August 25, 2017

Forest Service  
Attn: Forest Plan Revision  
Custer Gallatin National Forest  
10 E Babcock, P.O. Box 130  
Bozeman, MT 59771

We have studied the GIS methodology used by CGNF as described in the July, 2017 document “**CGNF Allotment Infrastructure & Wilderness Inventory.**”<sup>1</sup> Despite considerable effort and the best of intentions by CGNF staff, we have concluded that the methodology used is inconsistent with both the intent of the Wilderness Inventory, and the direction in the Planning Handbook, Chapter 70.

## Appendix 1

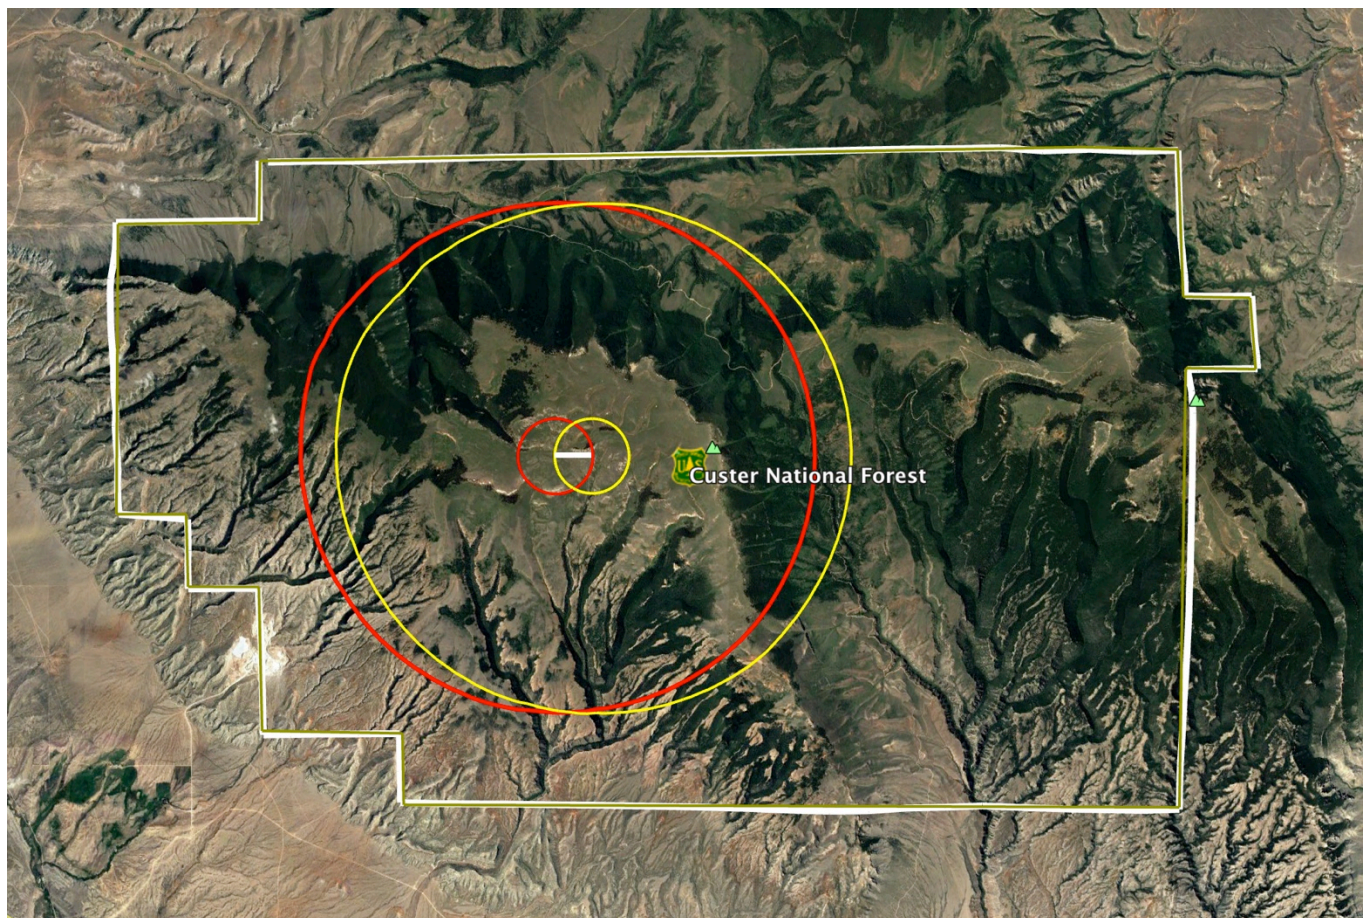
**The radius used to compute infrastructure density is inconsistent with the intent of the Wilderness Inventory. (Also see Appendix 1.)**

CGNF used a circle radius of 5,666 meters for this process. This is a radius of 3.5 miles and a diameter of 7.0 miles. Thus fences and water developments up to 3.5 miles away were included in the determination of “significant noticeability” of infrastructure at that point. The intent was to determine the visual impact on a person standing in the center of the 30 meter square cell. At a distance of 3.5 miles such features are very unlikely to be visible at all let alone “significantly noticeable.”

A circle radius of 0.5 mile = 800 meters or less would be much more consistent with the intent of the analysis. Range infrastructure beyond 0.5 mile is rarely substantially noticeable if it is visible at all. CGNF justifies the 3.5 mile radius used in footnote 3 on page 2: “*changing search radius generally provides similar outputs, so kept the default. In point density tool.*” This may, or may not, be true “*generally.*” It is not true in this case. Best practice would be to choose a radius consistent with the question the GIS model is intended to answer.

Only 2% of the area within the 3.5 mile radius circle is within 0.5 mile of the cell center. 98% of the area used by the CGNF methodology to compute the “density” value for that cell is beyond the “local” view of someone standing in that cell. Thus the calculation is strongly biased by distant infrastructure density probably unseen from the cell.<sup>2</sup>

CGNF's GIS model computed the range infrastructure density at the west endpoint of the white line from all the fences and water developments within the large red circle. Note that this includes most of Big Pryor Mountain and also includes area north of Pryor Mountain Road. (Part of Pryor Mountain Road is visible in the NE quadrant of the large circles.)

The range infrastructure density at the east endpoint of the white line was computed from the fences and water developments within the large yellow circle. Notice that the red and yellow circles almost entirely overlap. The calculated densities are nearly the same for the two points  $\frac{1}{2}$  mile apart. The only difference is due to range developments in the thin crescents between the red and yellow circles. Thus the only difference is due to fences and water developments 3+ miles distant.

The small circles illustrate how the GIS calculation would work using a  $\frac{1}{2}$  mile radius. Density would be computed from "local" range infrastructure within  $\frac{1}{2}$  mile of the point. Densities computed for two points  $\frac{1}{2}$  mile apart could be significantly different because only a fraction of the two circles overlap.

1. Use 0.25 mile or 0.5 mile for the radius to be more consistent with the subjective visual impact.
2. Follow the direction in 71.22b (10) and limit the range developments in the GIS calculations to those inside areas predetermined by the 5,000 acre area and road requirements in the Planning Handbook.
3. Run the model specifically considering the Big Pryor and Bear Canyon RWAs we have proposed. Again follow 71.22b (10) as in point 2 above.

**Map 1:** Water developments in the Pryors (small circles) and densities computed by GIS model (colors). Note that model reports the highest density (purple) in an area with no water developments.

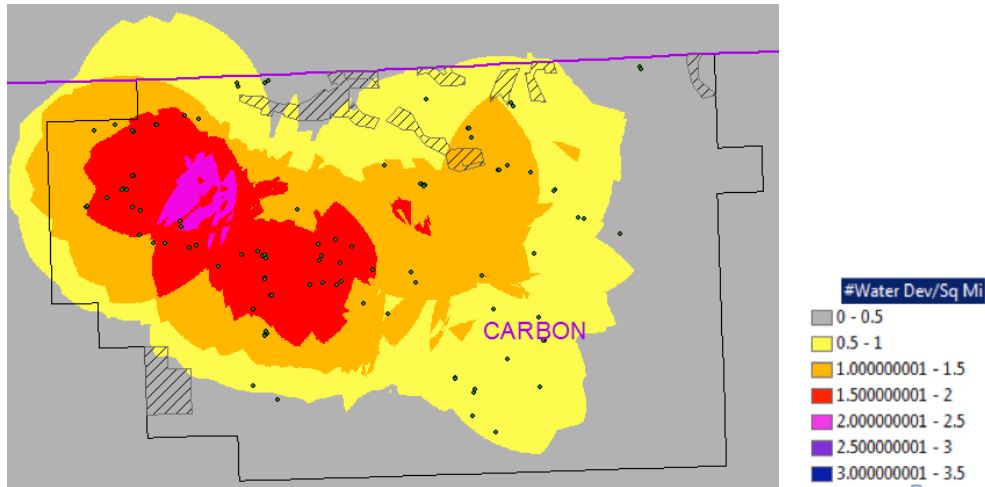
Even more embarrassing for the GIS model, it reports the highest water development density anywhere in the Pryors is within this timbered area without water developments. According to the GIS produced map<sup>4</sup> (See Appendix 2, map 1.), there is an area of nearly 1,000 acres with 2.0 to 2.5 water developments per sq. mile (purple color) in the heavy timber west of Big Pryor Plateau. This same map shows that there are no water developments in that "purple" area and for a considerable distance west, north and east. This anomaly alone is sufficient reason to doubt the credibility of the model and lead to a major revision.

The north boundary of the Wilderness Inventory in the Bear Canyon area as released by CGNF was immediately puzzling to us. (See Map 2 in Appendix 2. This boundary is the line between the yellow and light tan colors.) Area north of this boundary was excluded from the Inventory, but from the FS map it is clear that in the west part of the Bear Canyon RWA there are no developments for nearly two miles north from the boundary determined by the GIS model. In the east part there are only a couple stock ponds. Again the GIS model is responding to distant infrastructure.

The second map in Appendix 2 shows the water developments and fences reported by CGNF. We have added the red lines showing approximate boundaries of our proposed Big Pryor and Bear Canyon RWAs which mostly follow motor legal routes. (Ignore the colors on the map.) It is obvious from the FS map that there are very few water developments and fences within these proposed RWAs. This is even more true if a few developments very close to the boundary motor routes are excluded by slight adjustment of the boundaries.

**Map 2:** Water developments (small circles) and fences (black lines with tiny “X”es). Color coding is complex, but all areas NOT yellow or gray were excluded from the Wilderness Inventory. We added the red lines to indicate the boundaries of our proposed Big Pryor and Bear Canyon Recommended Wilderness Areas. Most of these boundaries are along motor legal routes. Note that there are very few water developments or fences within these proposed RWAs.
